SUBJECT: Troy Jensen Tile Outlet Review

TROY JENSEN PETITION FOR OUTLET REVIEW

SUBJECT: Troy Jensen Tile Outlet Review-Amendment 1

Martin County,
Minnesota
Wednesday, April 6, 2022

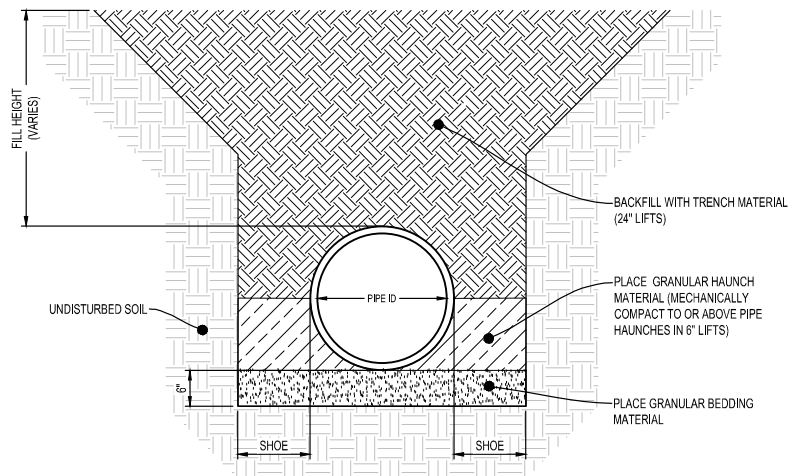
Due to the proposed private tile draining land from one watershed to another, the downstream crossings at 40th Street and 310th Ave were analyzed to compare the pre- and post-conditions in order to verify no reductions in system capacity would occur. Currently there are portions of the 220-acre sub watershed that drain downstream into the JD 414 main open ditch. The tile system will move the outlet of these acres upstream in the JD 414 main open ditch to the location of the pump/tile outlet. The existing mainline crossings are both 84-inch Reinforced Concrete Pipe culverts that reside at a 0.06% grade (40th Street) and a 0.45% grade (310th Ave), the crossings are currently in good condition and were recently repaired in 2018. It was observed that a slight reduction in capacity at the two crossings would occur due to the increased watershed size draining to the crossings. Table 2 below outlines the capacity of the crossings for the existing and proposed conditions.

The proposed private tile would cause a 4% capacity decrease on the 40th Street crossing and a reduction of 3% at the 310th Ave crossing. However, the capacity analysis is assuming the peak flows throughout the drainage area all reach the crossing at the same time. In reality the

timing within the system varies greatly due to potential storage and isolated basins within the watershed. The proposed private tile peak flow will arrive at the crossing before any the culvert is at full capacity, therefore the private tile project will not affect the existing culverts. When analyzing culvert capacities for open ditch systems, a $\frac{1}{2}$ inch to 1 inch per day drainage coefficient is recommended. Both the existing and proposed capacities of 40th street are within this range, but are slightly in the lower end of the capacity,

Agricultural drainage tile that resides under road crossings are subjected to heavier loads that pose a risk to pipe integrity. Traditional single wall private tile has been shown to collapse when exposed to heavier loads, like the road crossing at 40th Street. It is the engineer's recommendation that the tile under 40th Street be either dual-wall high density polyethylene (HDPE) or reinforced concrete pipe, in order to increase the lifespan of the system and prevent any future road maintenance due to tile failure under the road surface. Please see the attached specifications for agricultural drain tile and road crossings. Rip rap should also be place at the tile outlet into the open ditch to prevent erosion of the ditch banks. The rip rap should be sized to handle the velocity existing the pipe and prevent scour into the JD 414 open ditch.

Based on the information provided with the private tile outlet from JD 314 into JD 414, there will be insignificant impacts on the overall drainage to JD 414. While the culvert capacity under 40th street may be slightly undersized, rerouting the tile from JD 314 as shown will not burden the crossing to a capacity under the minimum recommended capacities. Therefore, the proposed tile reroute design as shown is acceptable from a drainage capacity standpoint.
